DRAINAGE ANALYSIS

PROJECT DESCRIPTION:
THE PROJECT SITE IS LOCATED AT 230 TOHATCHI TRAIL NW. THE 1.6363 ACRE SITE IS BOUND BY THE MRGCD ALAMEDA DRAIN TO THE NORTH & EAST, CARSON RD NW TO THE NORTHEAST, TRACTS A & B – LAND OF TONY GREGO TO THE EAST, LOT 1 –LANDS OF DELLA SANCHEZ TO THE SOUTHEAST, LOTS 7, 8 & 9 –TOHATCHI ADDITION AND TOHATCHI TRAIL NW TO THE SOUTH.

TITLE: **MASTER GRADING & DRAINAGE PLAN**
NOT FOR CONSTRUCTION

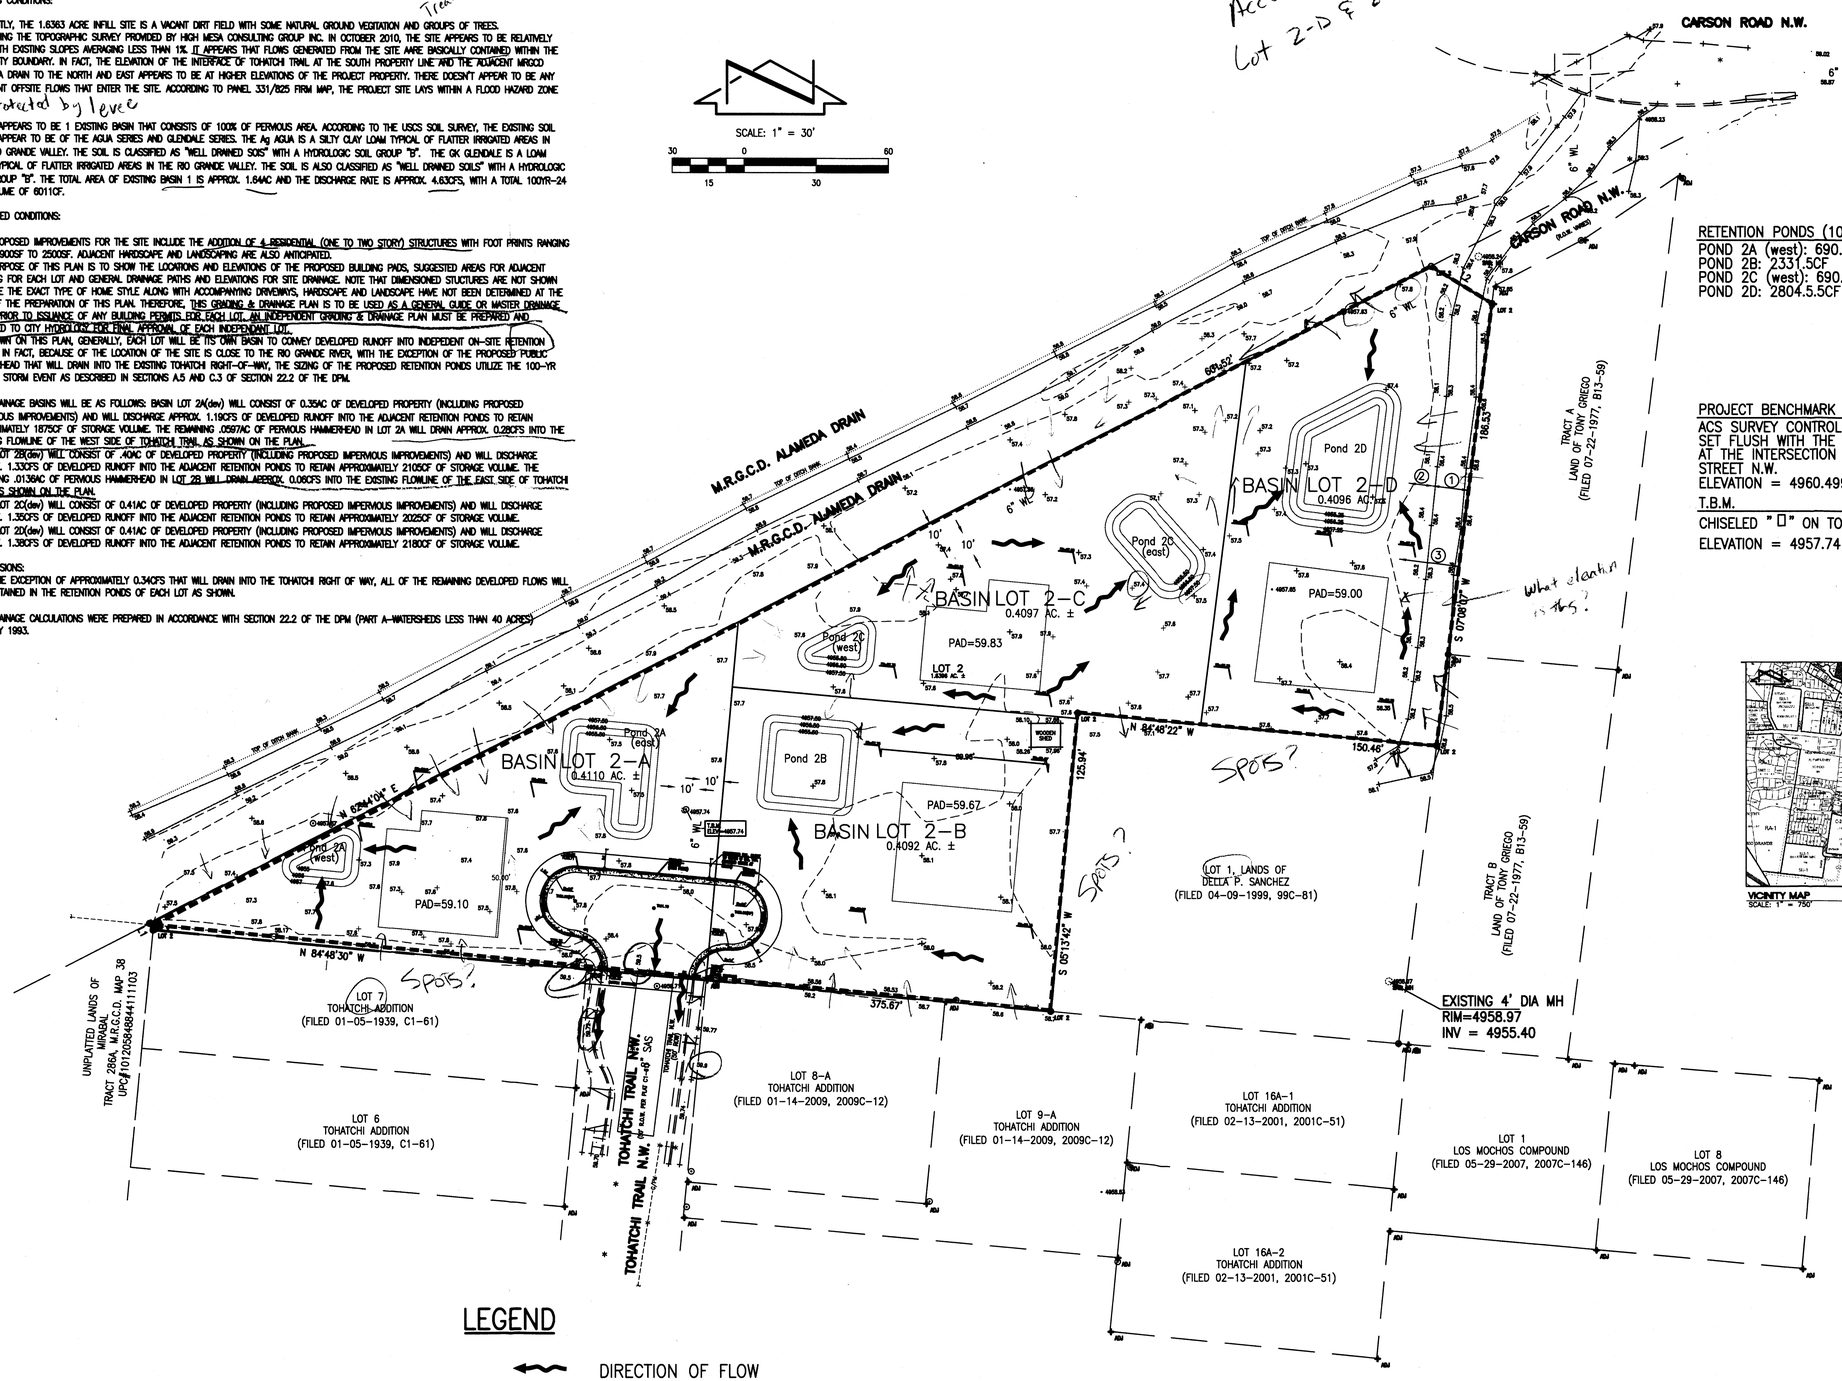
Treatment A

CURRENTLY, THE 1.6363 ACRE INFILL SITE IS A VACANT DIRT FIELD WITH SOME NATURAL GROUND VEGITATION AND GROUPS OF TREES. ACCORDING THE TOPOGRAPHIC SURVEY PROVIDED BY HIGH MESA CONSULTING GROUP INC. IN OCTOBER 2010, THE SITE APPEARS TO BE RELATIVELY FLAT WITH EXISTING SLOPES AVERAGING LESS THAN 1%. IT APPEARS THAT FLOWS GENERATED FROM THE SITE ARE BASICALLY CONTAINED WITHIN THE PROPERTY BOUNDARY. IN FACT, THE ELEVATION OF THE INTERFACE OF TOHATCHI TRAIL AT THE SOUTH PROPERTY LINE AND THE ADJACENT MRGCD ALAMEDA DRAIN TO THE NORTH AND EAST APPEARS TO BE AT HIGHER ELEVATIONS OF THE PROJECT PROPERTY. THERE DOESN'T APPEAR TO BE ANY ADJACENT OFFSITE FLOWS THAT ENTER THE SITE. ACCORDING TO PANEL 331/825 FIRM MAP, THE PROJECT SITE LAYS WITHIN A FLOOD HAZARD ZONE "X". Protected by levee
